## Evaluation of proposed move for Water Right No 19712

Proposed: Move water right no. 19712 a distance of 1,212 ft to the southeast.

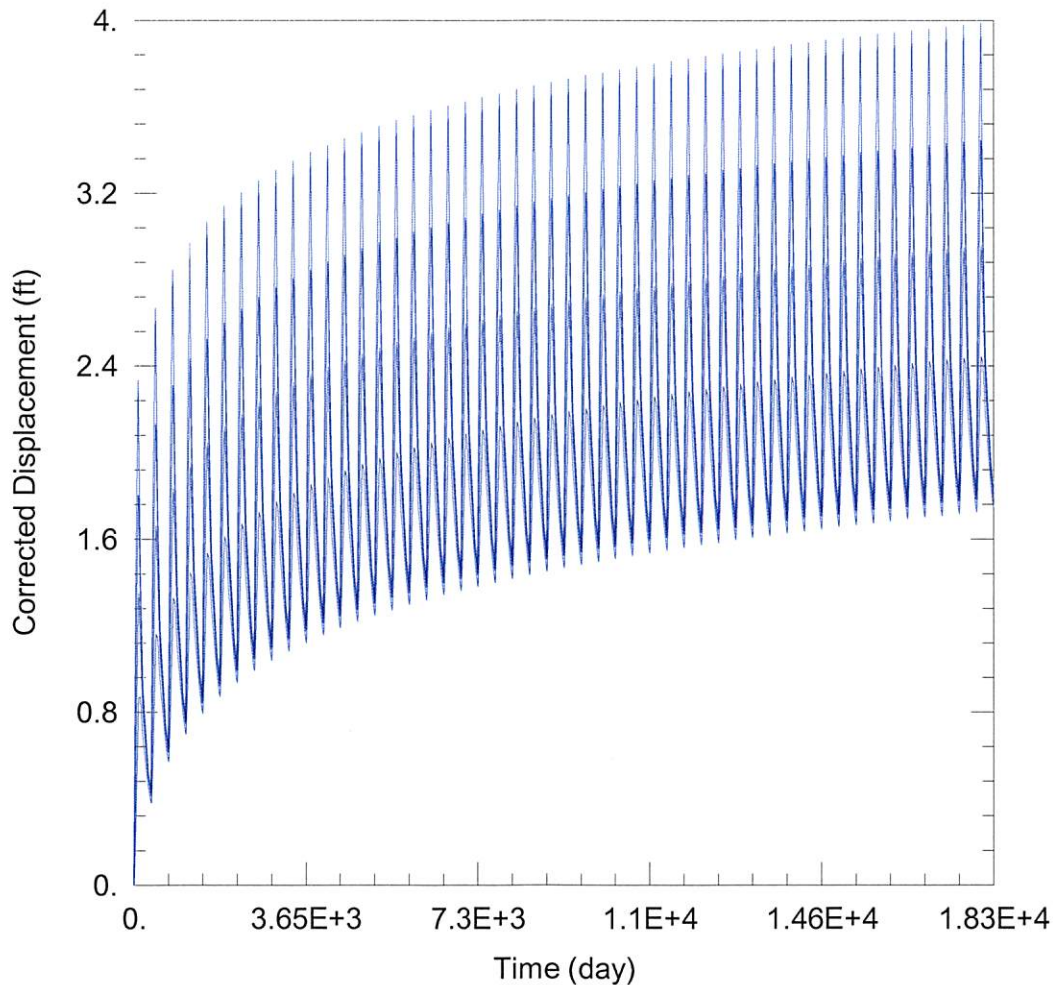
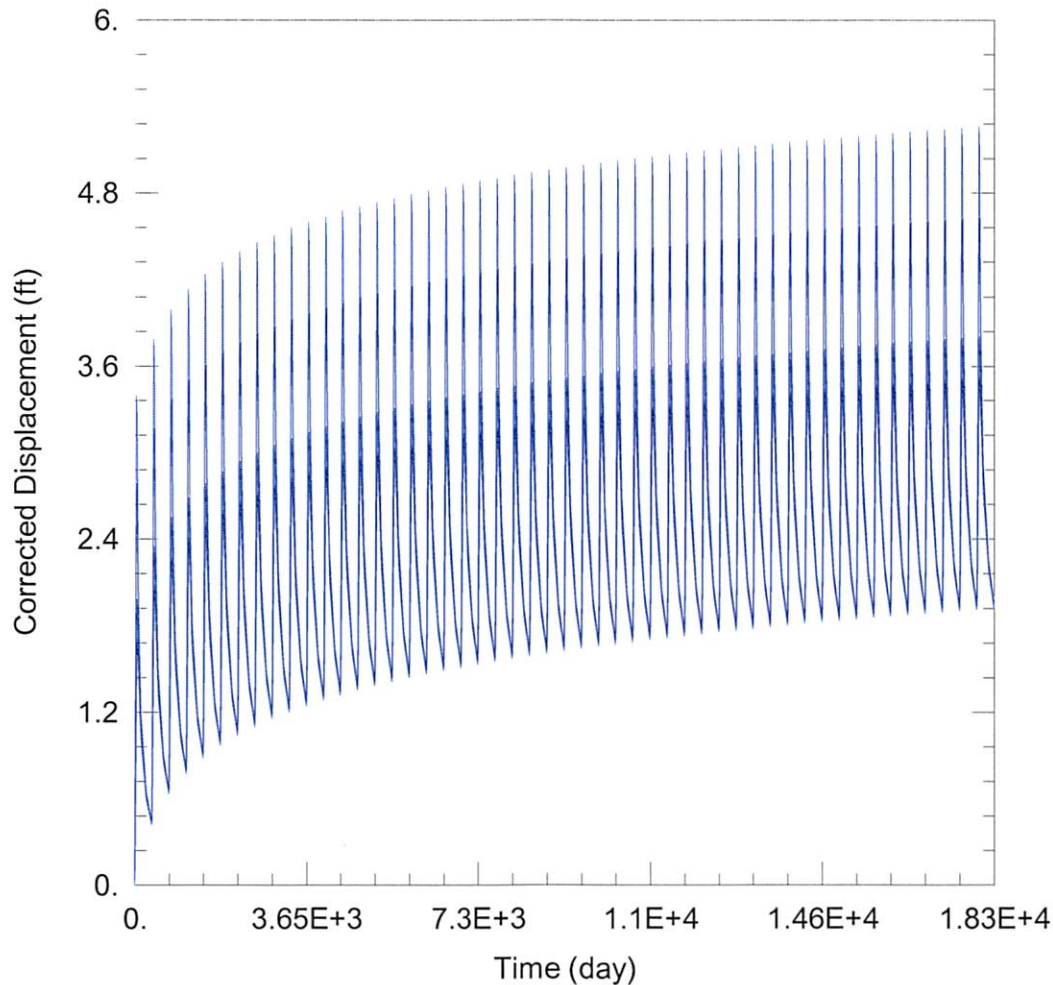
27188 ID 2:	Current drawdown = 3.99 ft
	Proposed drawdown = 5.26 ft
	Net drawdown = <b>1.3 ft</b>
27188 ID 4:	Current drawdown = 3.45 ft
	Proposed drawdown = 3.80 ft
	Net drawdown = <b>0.4 ft</b>

11906:                   Current drawdown = 2.96 ft  
                              Proposed drawdown = 4.58 ft  
                              Net drawdown = **1.6 ft**

39709:                   Current drawdown = 2.96 ft  
                              Proposed drawdown = 4.63 ft  
                              Net drawdown = **1.7 ft**

Domestic 23-32-31:    Current drawdown = 2.45 ft  
                              Proposed drawdown = 3.53 ft  
                              Net drawdown = **1.1 ft**

Net drawdown does not exceed the drawdown allowance of 3.5 ft for any wells within 1 mile of the proposed point of diversion, so critical well analysis is not necessary.

The proposed change should result in minimal effects on neighboring wells and is unlikely to create an impairment situation. GMD3 staff recommends approval of the application.
